Town of Parker Community Development Department  
 Development Review Division  
 Attention: **Stacey Nerger**

Application Type: **Site Plan**  
 Status: **First Referral**  
 Application Name: **Parker and Pine F1 L2 - Gas Station & Conv. Store**  
 Case/AP#: **SP20-0019**  
 Referral Received: April 8, 2020  
 Comments Due: May 6, 2020

Review date: **April 27, 2020**  
 Plan reviewer: **Randall L. Capra, [rcapra@parkeronline.org](mailto:rcapra@parkeronline.org)**  
 Phone: 303.805.3169

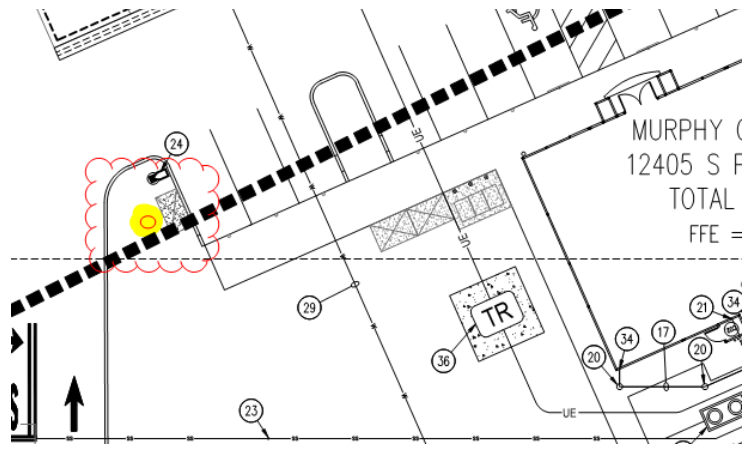
2. Per the requirements of [18 IFC Section 503.1.1 Buildings and Facilities] approved fire apparatus access roads shall be provided for every facility, building, portion of a building hereafter constructed or moved into or within the jurisdiction. The fire apparatus access road shall comply with the requirements of this section and shall extend to within 150 feet of all portions of the facility and all portions of the exterior walls of the first story of the building as measured by an approved route around the exterior of the building or facility (the building is a 155+ feet long and 50.56 feet wide and cannot meet the requirement as measured from the center line of the fire apparatus as measured by an approved route from any point that a fire engine might park when responding to a call at this building). This submittal does not provide for this requirement of the code. Per the requirements of the code, the fire code official is allowed to increase the dimension of the 150 feet provided that the applicant meets Exception 1.1 of this section... "The building is equipped throughout with an approved automatic sprinkler suppression system installed in accordance with section 903.1.1, 903.1.2, or 903.3.1.3. *The applicant has indicated that they are unsure whether this comment is applicable; the comment is very much applicable. The private drives will not be utilized (except for a catastrophic response and Parker Road will never be used for emergency response. This would then indicate that the applicant is required to provide access internally. The applicant was given this information so as to they can meet this requirement, fully. To further help the applicant understand this question, working off of internal roads can create access issues with regard to getting additional apparatus onto the site as well as getting civilians off the site... as well as redeploying apparatus as they come in service.*

*For the applicant's clarity, I have provided a marked up site plan to address the crucial elements of this site; access, as shown, must be provided at all times.*

**Satisfied; applicant has addressed with current submittal. Applicant has provided the auto-turn analysis and provided associated fire lane signage.**

**FIRE CODE REVIEW BLOCK**

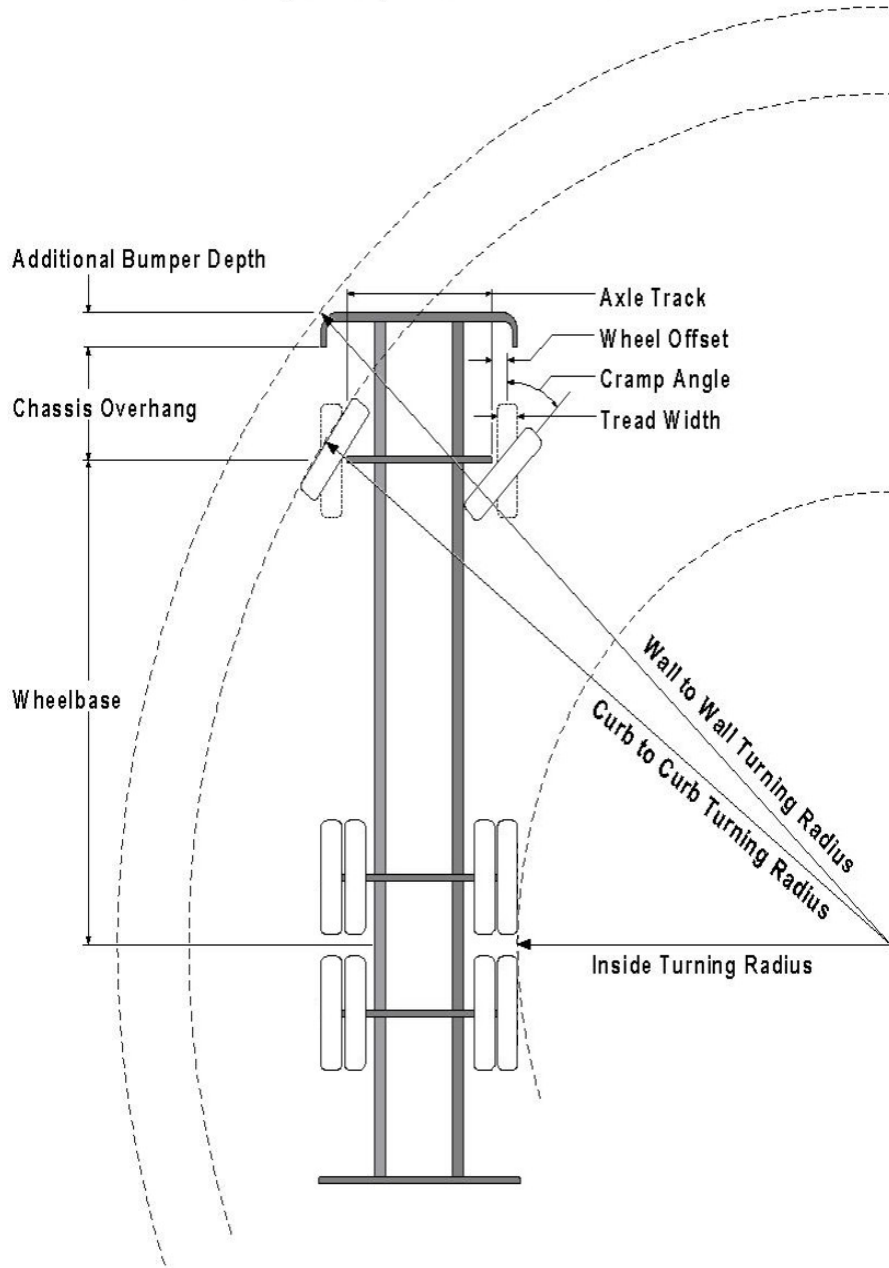
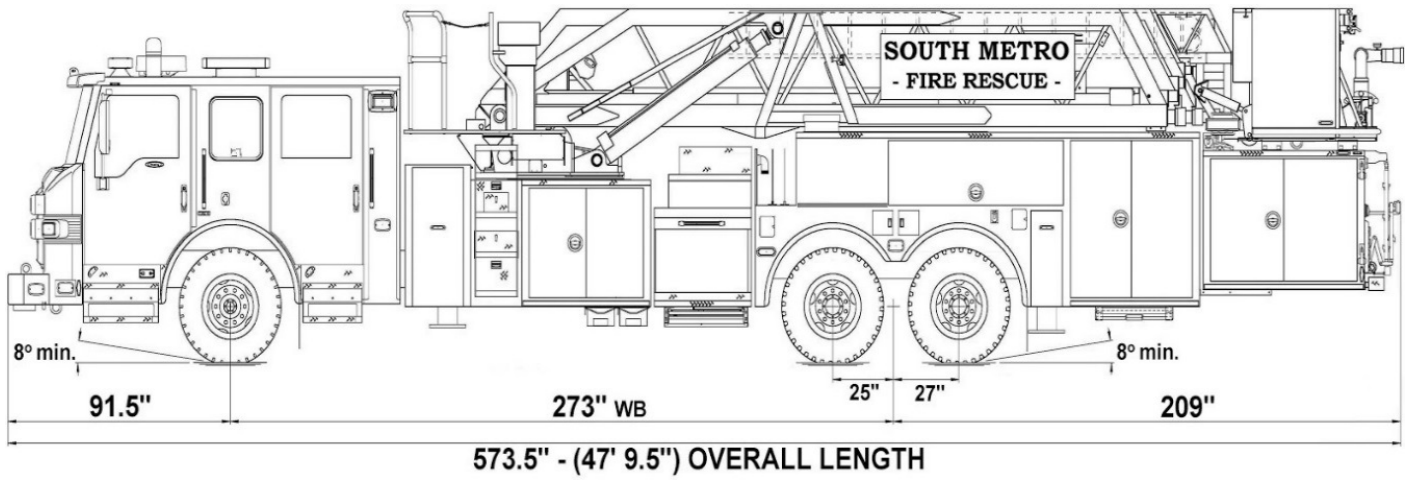
- 6. The applicant has not included the required fire life safety signature block for Fire Life Safety on either a cover page or the overall utility page. This issue must be addressed when resubmitting. *Satisfied; applicant has addressed with current submittal. The applicant has added the signature blocks as required.*

Note - An updated signature block has been created with regard to the utility drawing package; typically, this signature block is located on the cover sheet and the overall utility page of the water drawings. The signature block is noted below; address as applicable.
